Project	Steamboat Base Village Redevelopment	Date	07/23/2021
Project Location	Steamboat, Colorado	Architect's Project Number	03.7835.000
Owner/Client	Alterra Mountain Company / East West Partners	File	6BL This is page 1 of 2
To	Saunders Construction Inc.	Attention	Bryan Sculthorpe
Address	86 Inverness Place North		
City	Englewood	State	CO Zip Code 80112
Delivered via:	<input type="checkbox"/> Messenger <input type="checkbox"/> Hand carried <input type="checkbox"/> Facsimile <input type="checkbox"/> Express <input type="checkbox"/> Pick-up <input type="checkbox"/> E-mail Address <input type="checkbox"/> Mail <input type="checkbox"/> UPS <input checked="" type="checkbox"/> Website Address BIM360

Bulletin Number - BP3 Promenade - 06

Description of Changes

This bulletin addresses the following:
Landscape planters, site walls, associated grading
Telecom sheet updates for on mountain coordination

1A-L7-04

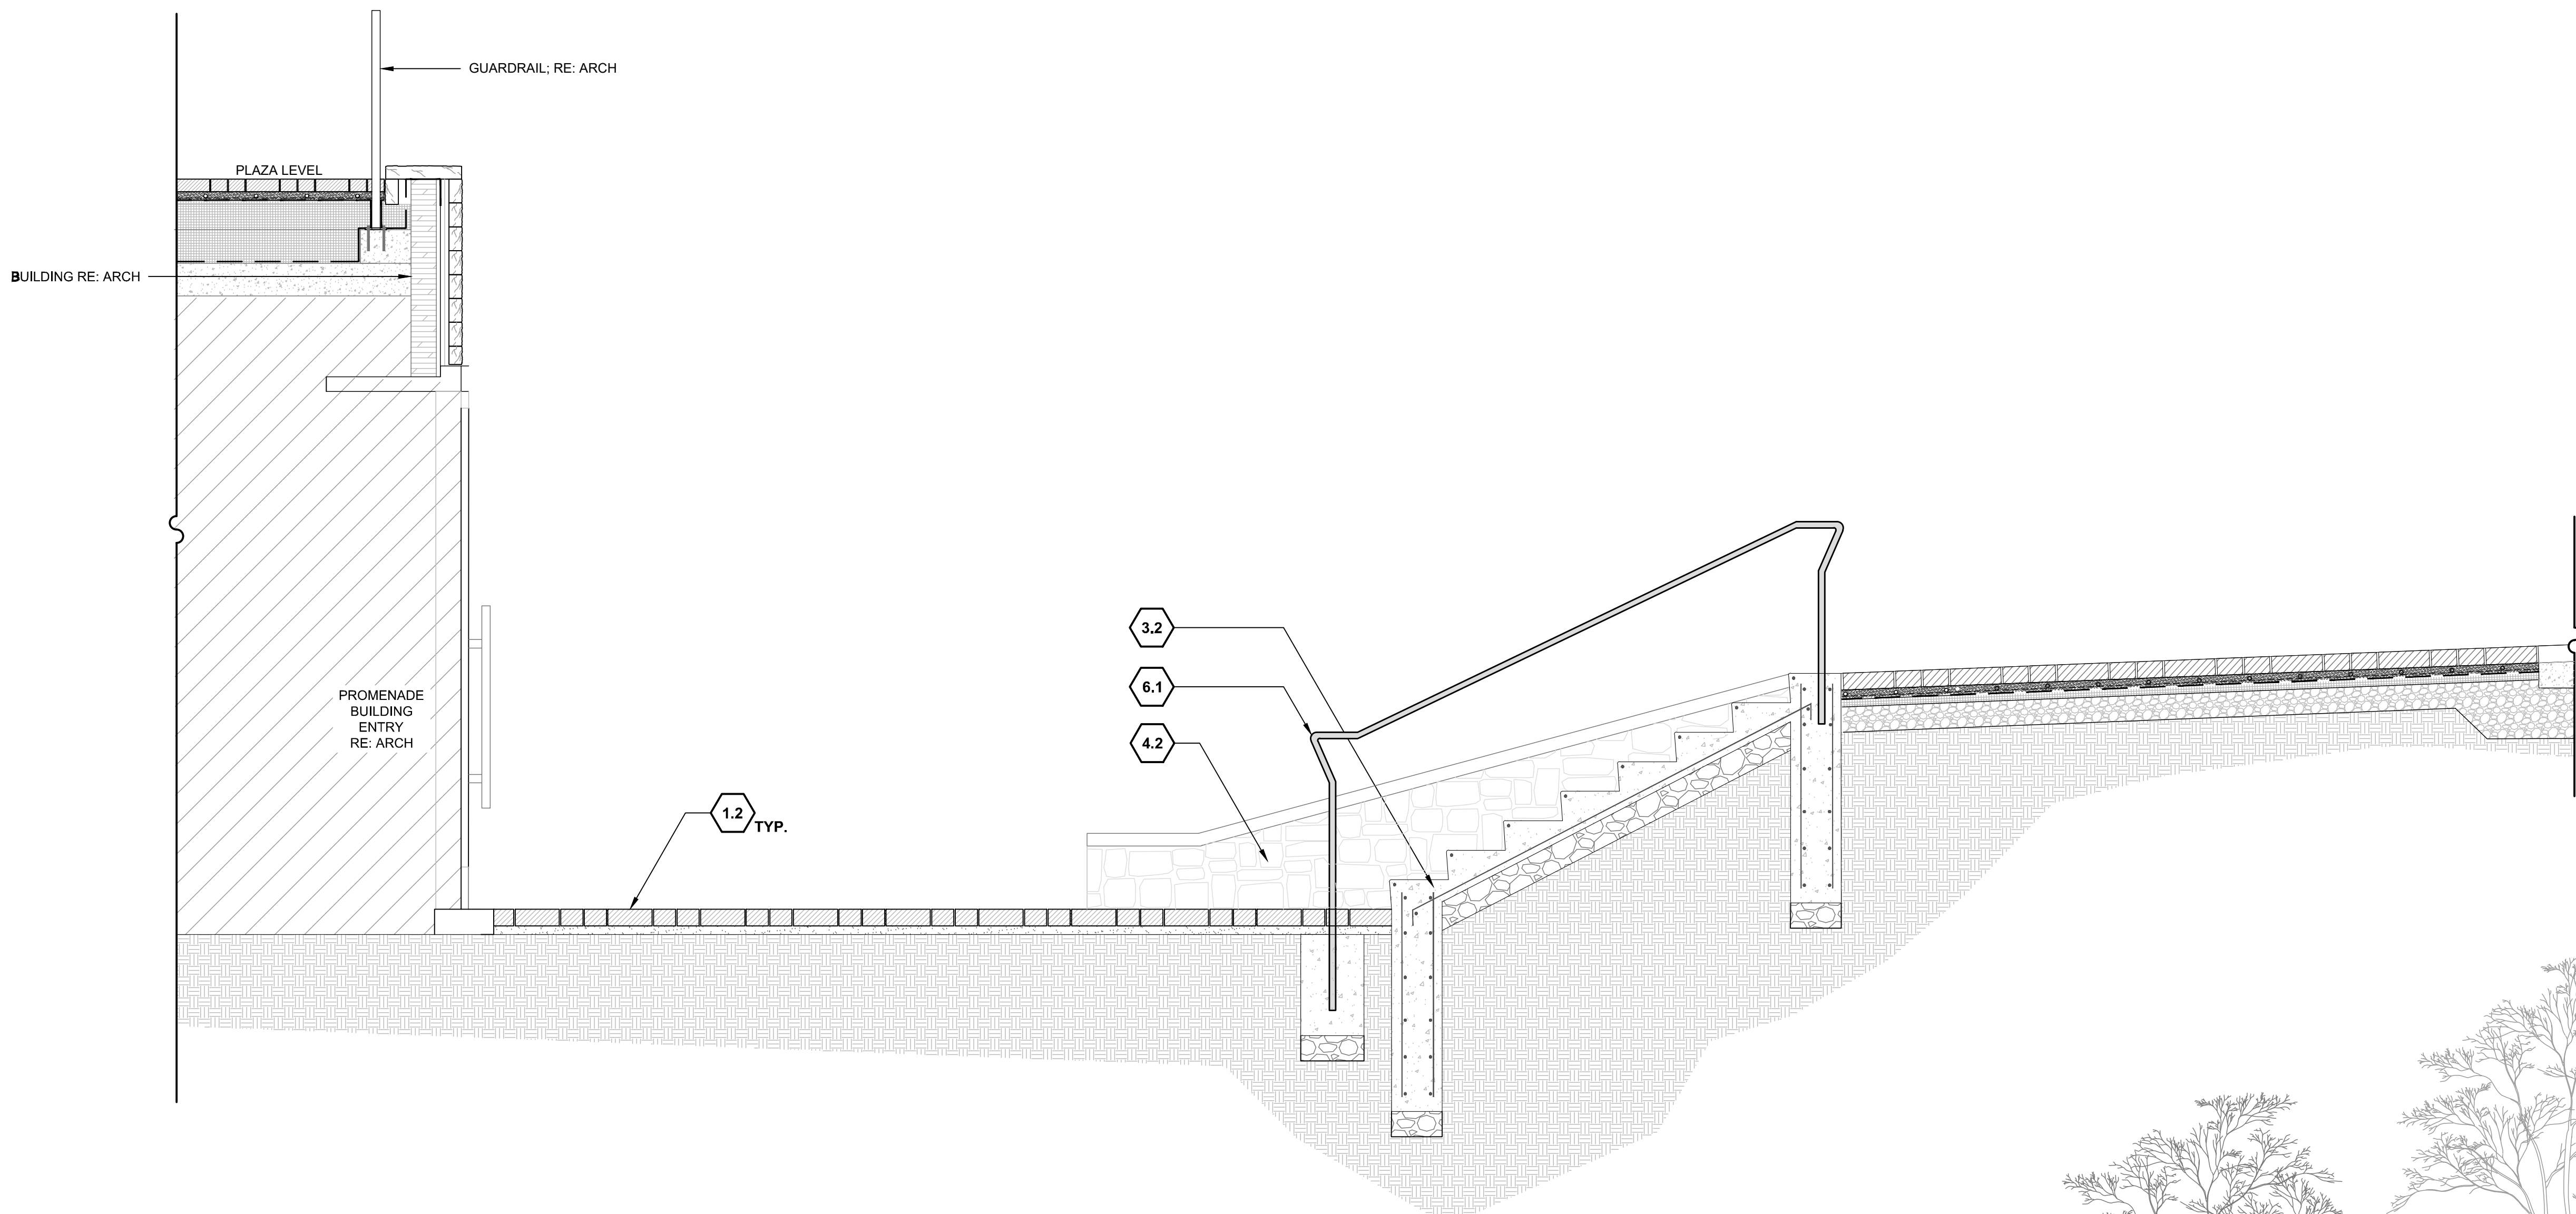
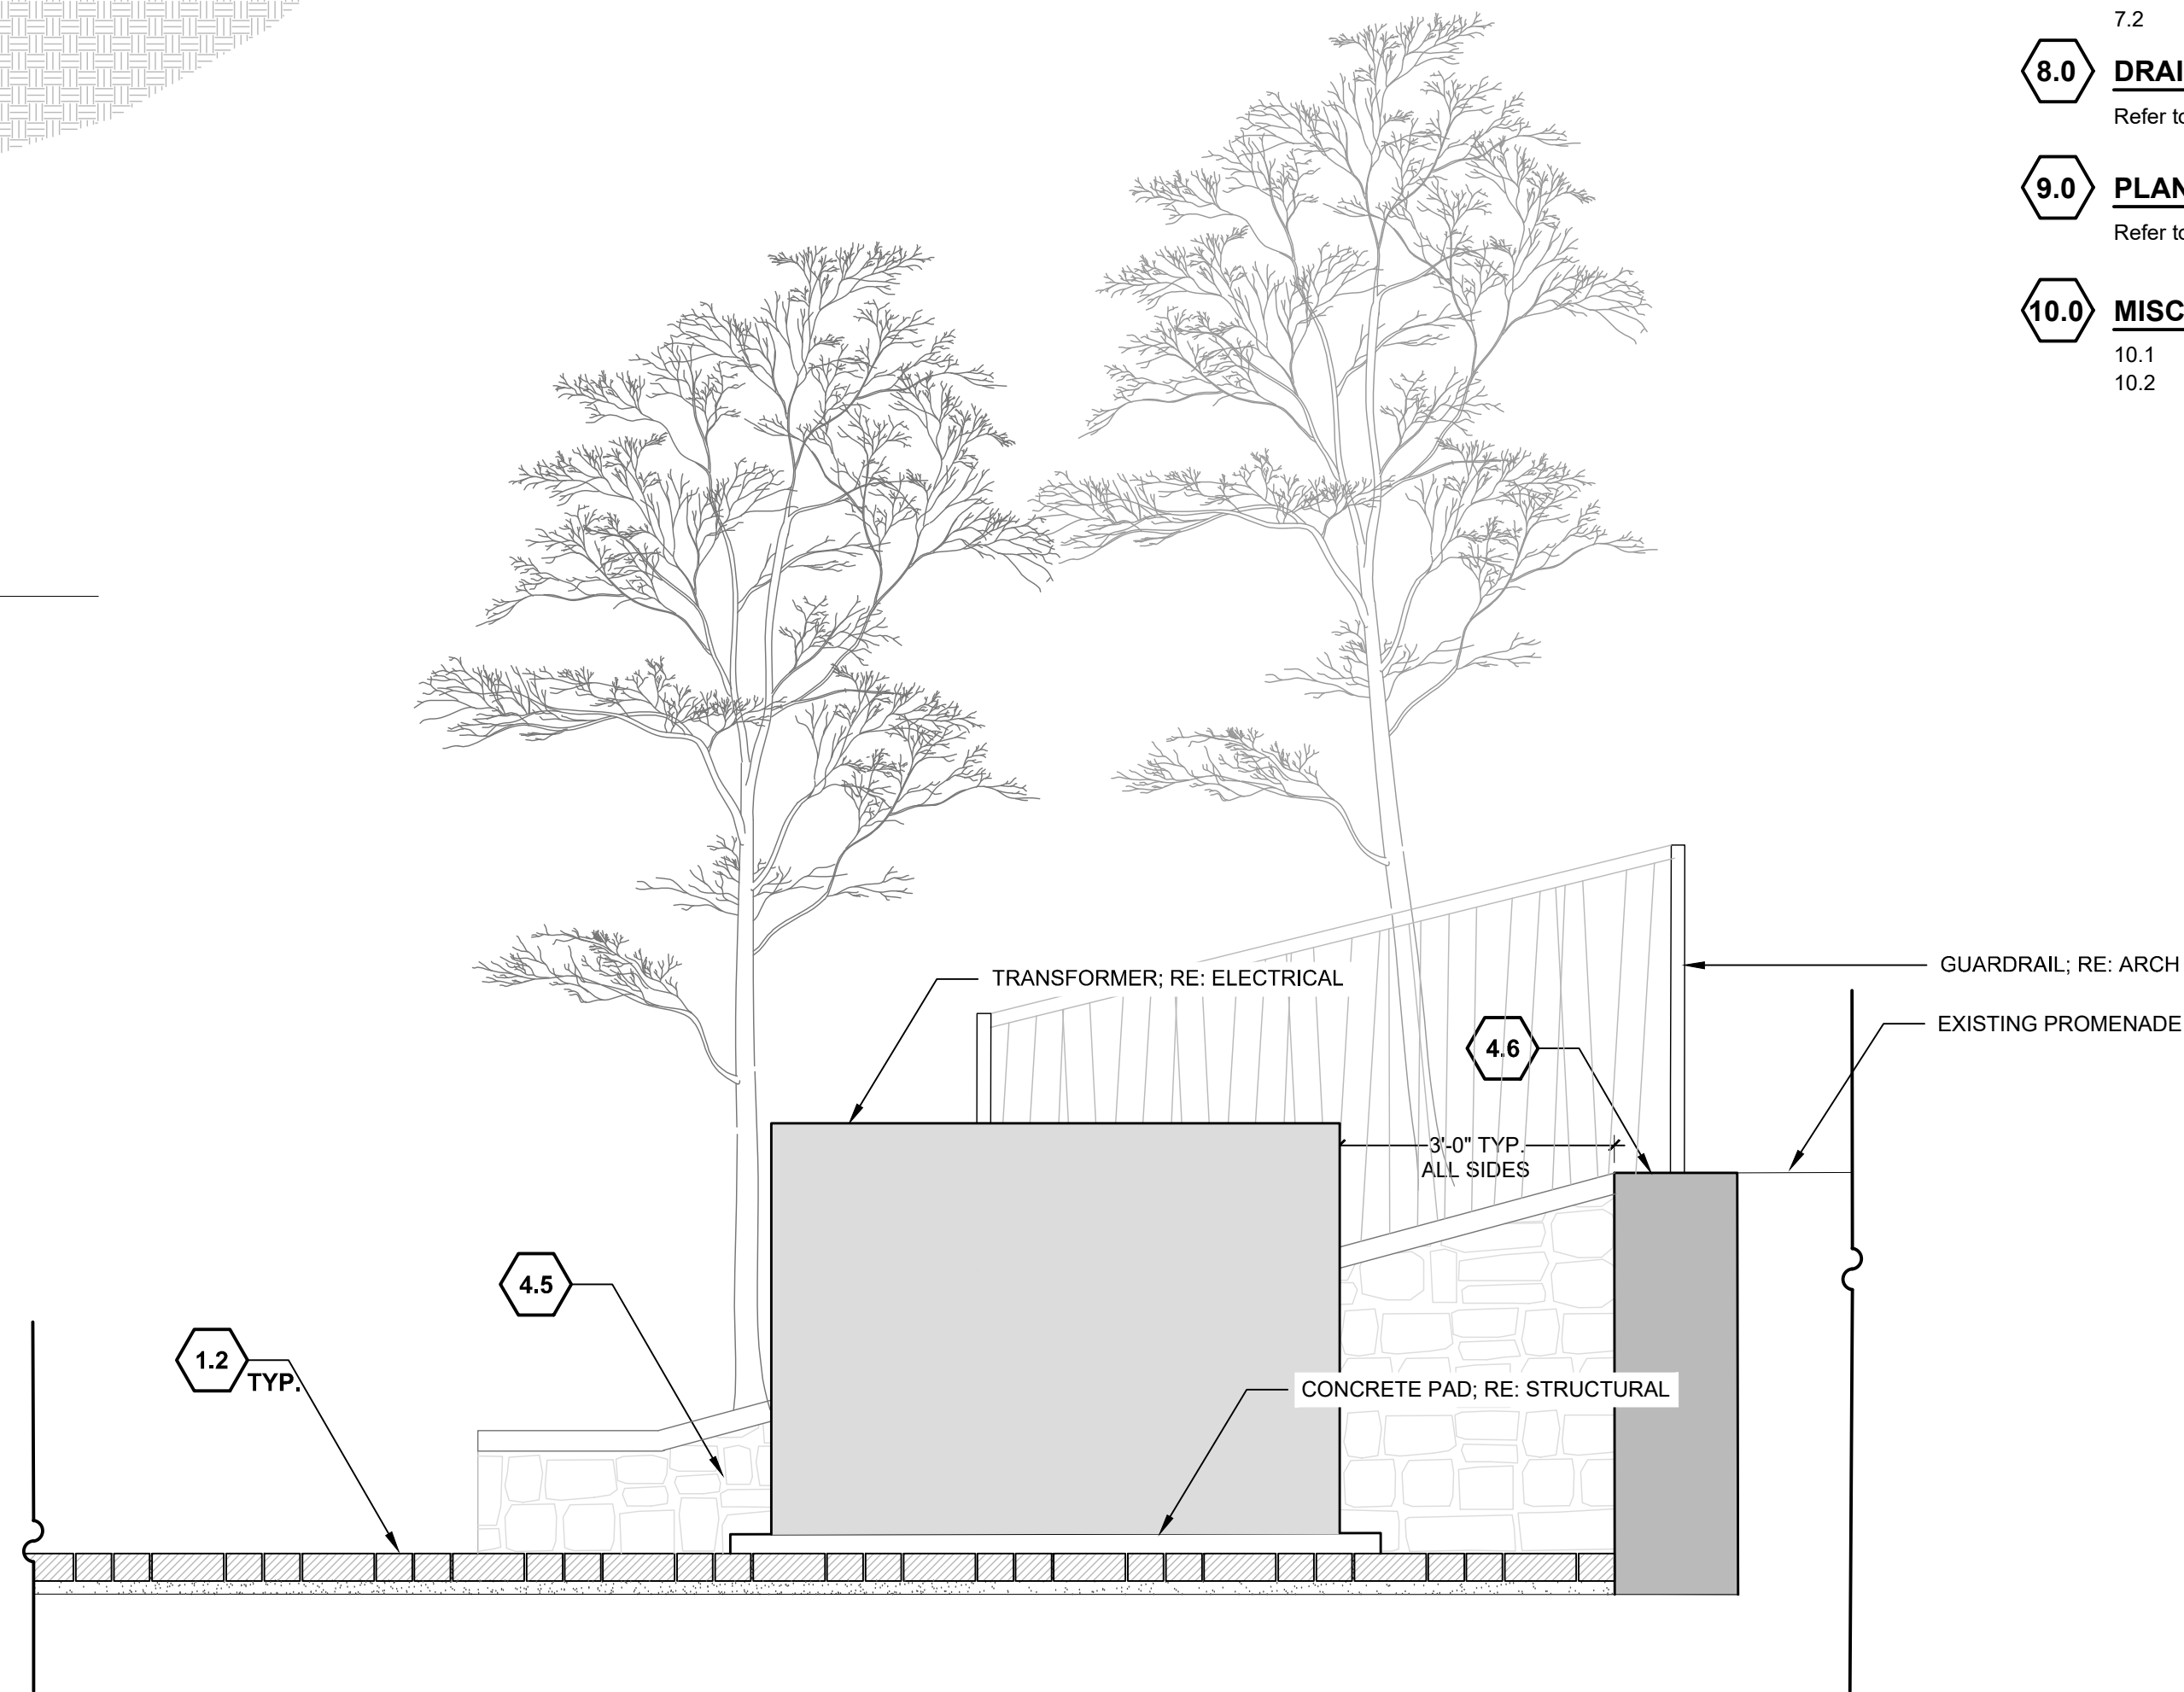
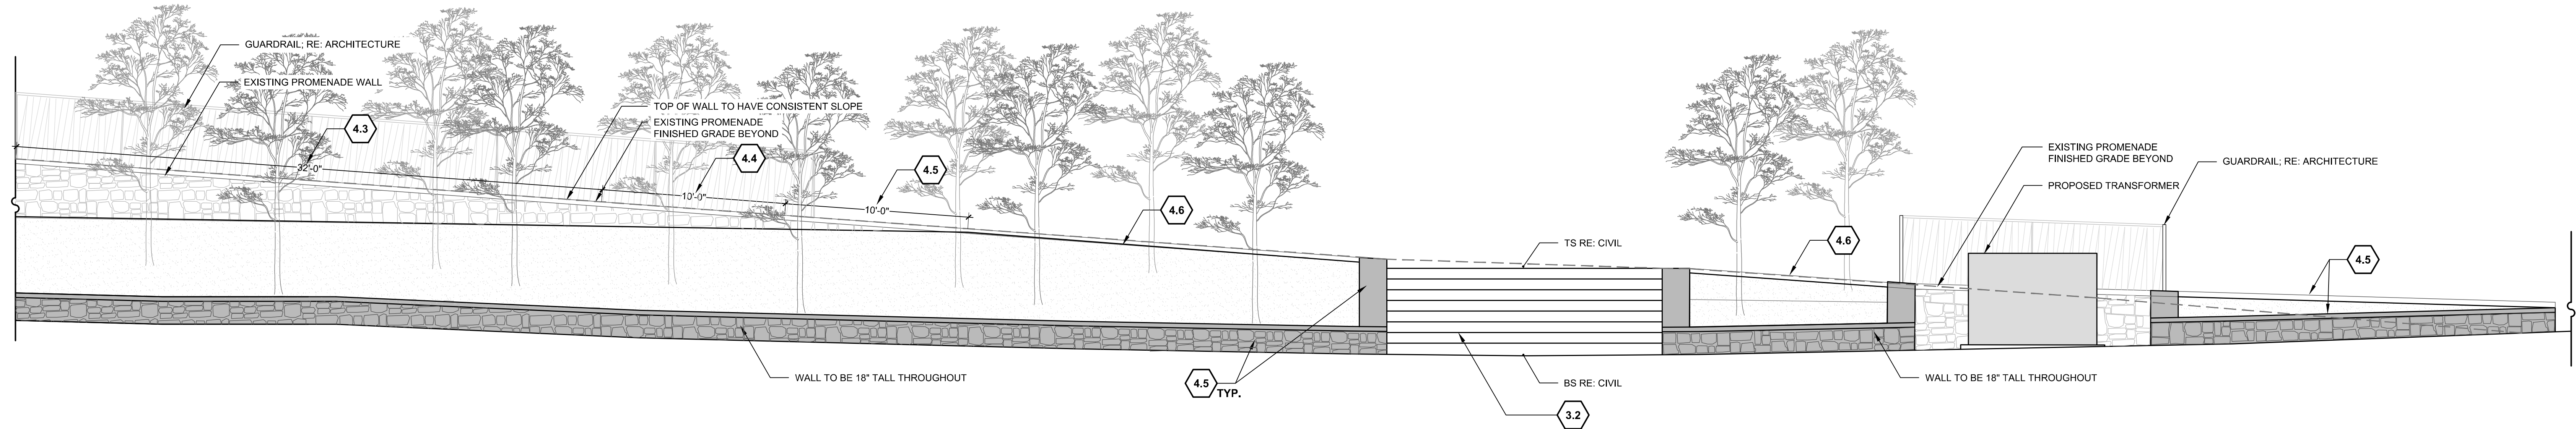
1A-L7-02 Site Details	Section 2 revised to include wall type 5.
1A-L7-03 Site Details	Sections 2 and 3 revised/added to show wall details type 3 and 4.
1A-L7-04 Site Details	Section/Elevation 1 title change to wall type 2.
1A-L7-08 Composite Sections	Elevation 2 added and elevation 3 revised to show relationship of southern promenade walls and transformer.
1A-L7-11 Site Details	New sheet showing wall types 5 and 6.
1A-L8-01 Planting Plan	Eastern tree removed from northeastern planter, shrubs and groundcovers reduced to accommodate new planter size.
1A-L8-02 Planting Plan	Trees, shrubs and added to fill larger planter at lower promenade level.
Irrigation Sheets:	
1A-IR-01 Irrigation Plan	Adjusted irrigation to match new planter geometries.
